Product Change Notice (PCN)

PCN Number: **PCN-0456192R-01**

Product(s) Affected: **PJ-042**

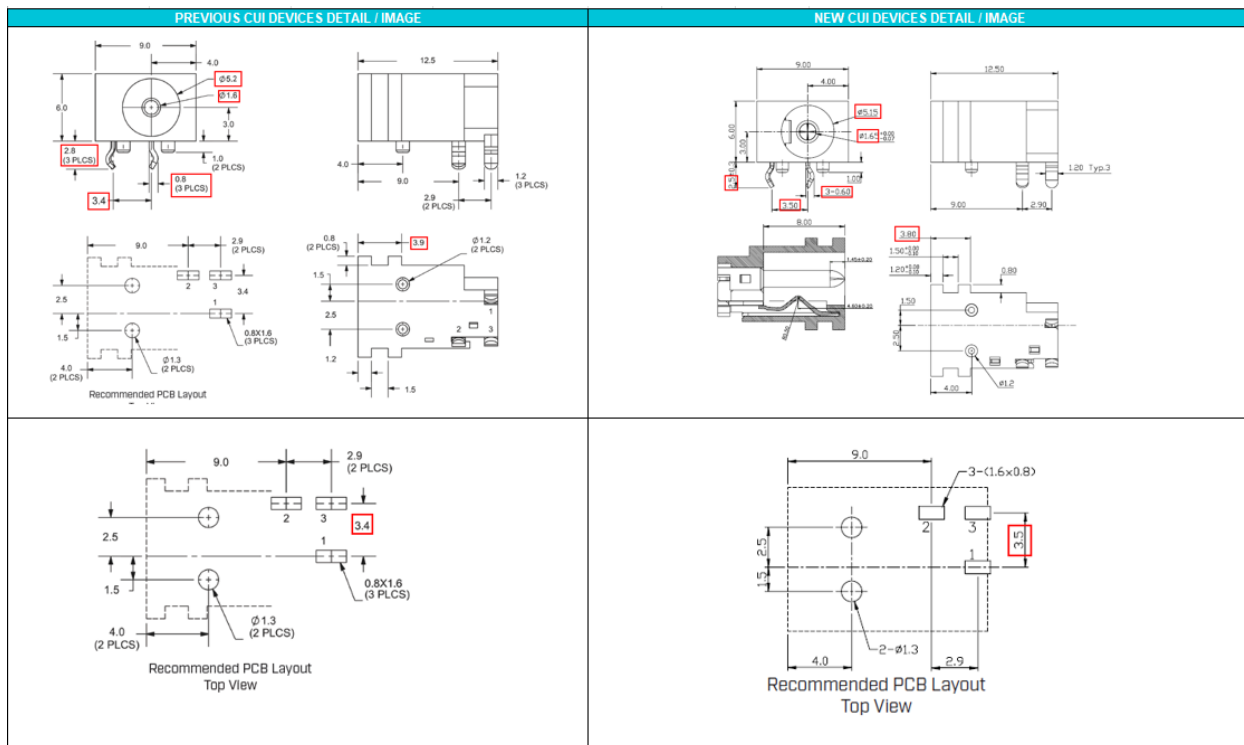
Description of Change: **New Factory Location. Product re-engineered for improved manufacturability and production yield. See image below for reference and check CUI Devices website for updated drawing. Cosmetic differences may be visible and not affect the form fit and function of the product.**

PREVIOUS CUI DEVICES DETAIL / IMAGE			NEW CUI DEVICES DETAIL / IMAGE		
DESCRIPTION	MATERIAL	PLATING/COLOR	DESCRIPTION	MATERIAL	PLATING/COLOR
center pin	brass	tin	center pin	bronze	tin
terminal 1	brass	tin	terminal 1	bronze t=0.35	tin
terminal 2	phosphor bronze t=0.3	tin	terminal 2	B2-Cu t=0.30	tin
terminal 3	brass t=0.3	tin	terminal 3	brass t=0.40	tin
housing	PAB6 (UL94V-0)	black	housing	PAB6-30%GF (UL94V-0)	black
MATING PLUG Jack Insertion Depth: 7.8 mm			MATING PLUG Jack Insertion Depth: 8.0 mm
